# Access Compliance Report

## Public Rights-of-Way

### (Pedestrian Signals)

| ADA ID: D7DCA6FC1305                    | Signal Type: One Push Button-Non APS | Overall Compliance: No                  | Severity Score: BTN 1: N/A BTN 2: N/A No BTN: N/A |

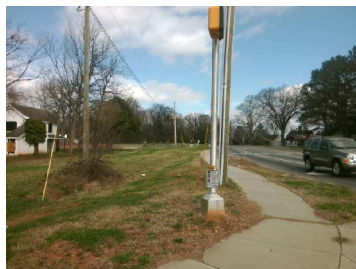
PROW/ADA: , TMUTCD 4e.08, R404.2, R404.7.3, R404.7.2

| Compliance | Description                             | Data    | Compliance | Description                            | Data         |
|------------|-----------------------------------------|---------|------------|----------------------------------------|--------------|
| No         | B 1 PARA Approach Reach (in)            | 13.0    | N/A        | B 2 PARA Approach Reach (in)           | N/A          |
| No         | B 1 PARA Approach Width (in)            | 48.0    | N/A        | B 2 PARA Approach Width (in)           | N/A          |
| No         | B 1 Clear Floor Space XSlope (%)        | 3.1     | N/A        | B 2 Clear Floor Space XSlope (%)       | N/A          |

| No  | B 1 DistanceTo Curb (in)  | 127.0 | N/A | B 2 DistanceTo Curb (in)  | N/A |

Possible Solutions: Replace Signal Push Button With APS Button on New Post. Remove & Relocate Sign.
